APPLICATION NO.	FILING DATE	FIRST NAMED INVENTOR	ATTORNEY DOCKET NO.	CONFIRMATION NO.
10/580,553	05/26/2006	Daisuke Murakami	050388-0046	5981
20277 7590 12/24/2008 MCDERMOTT WILL & EMERY LLP 600 13TH STREET, N.W. WASHINGTON, DC 20005-3096				
EXAMINER				
ADDRESSEE, SARA				
ART UNIT		PAPER NUMBER		
3724				
MAIL DATE		DELIVERY MODE		
12/24/2008		PAPER

# Office Action Summary

## **DETAILED ACTION**

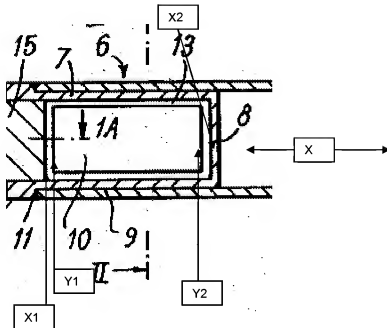
vibrates during cutting ('438, col. 3, lines 24-33). Furthermore, regarding claim 21, New teaches the tool being an overhung boring bar for machining bores of non-uniform diameter along their length, therefore, the cutting tool is expected to generate vibrations causing displacement in the horizontal direction (arrow X below) during machining, whereby the vibration direction (X) is substantially perpendicular to the first and second flat inner wall surfaces (X1, X2) ('438, col. 1, lines 5-8) (note: this concept is also evidenced by Muller et al., USP 3,663,116, col. 1, lines 22-25). New also discloses although chatter is a resonance phenomenon, the frequency of chatter vibrations is not solely dependent on characteristics of the boring bar, but on several other factors as well, such as the cutting conditions and the material of the workpiece ('438, col. 6, lines 52-61). Regarding claim 15, New teaches said pocket having first and second flat inner wall surfaces (X1, X2: see figure below) opposed to each other, and wherein said vibration suppressing piece (10) has third and fourth flat surfaces (Y1, Y2: see figure below) and is received in said pocket such that said third and fourth surfaces face said first and second surfaces, respectively, with a clearance defined between said first and second surfaces and said vibration suppressing piece, said first, second, third and fourth surfaces being oriented so as to cross the direction in which said holder vibrates during cutting. Regarding claim 16, New discloses all of the claimed limitations (i.e. pocket and vibration suppressing piece having flat surfaces that are perpendicular to the central axis of the shank wherein the opposed inner wall surfaces X1, X2 of said pocket having a greater area than other surfaces Y1, Y2, of said vibration suppressing

piece: see figure above) except for the sections being rectangular). It would have been an obvious matter of design choice to make the different portions of the vibration suppressing piece of whatever form or shape was desired or expedient to fit the bore/pocket it is received in. A change in form or shape is generally recognized as being within the level of ordinary skill in the art, absent any showing of unexpected results. Regarding claim 17, New teaches clearance of 0.10 to 0.13 mm and although the actual choice of length and diameter of the damper mass is not critical, the best results are attained with a clearance in the range 0.107 to 0.122 mm (which reads on the claimed limitation 0.01- 0.5 mm) ('438, col. 3, lines 23-30). Regarding claim 22, New teaches a cutting tool having a damper assembly consisting of a closed cavity in the bar in which is located a damper mass having a damping clearance around it, and forward of the cutting tool a second damper assembly which also consists of a closed cavity containing a damper mass surrounded by a damping clearance ('438, figure 3 and col. 4, lines 29-38). Regarding claims 18 and 19, New teaches in figures 1 and 2, said pocket having a width that is 20-100% of the diameter of the shank, a height of 5-70% of the height of the shank and an axial length of 50-250% of the diameter/height of the shank. Furthermore, New teaches the actual choice of length and diameter of the damper mass is not critical ('483, col. 1, liens 27-29). Regarding claim 20, New teaches the shank being made of cylindrical steel tube (2) while the vibration suppressing piece (10) is made of heavy alloy ('438, col. 3, lines 4-5 and lines 18-24). Regarding claims 23 and 24, New teaches a blind hole and Examiner is considering the sleeve (7) to be the sealing means (also see

figures 9 and 10). Regarding claim 25, it would have been obvious to one having ordinary skill in the art at the time the invention was made to make the shank and the head separate pieces, because it has been held that constructing a formerly integral structure in various elements involves only routine skill in the art.
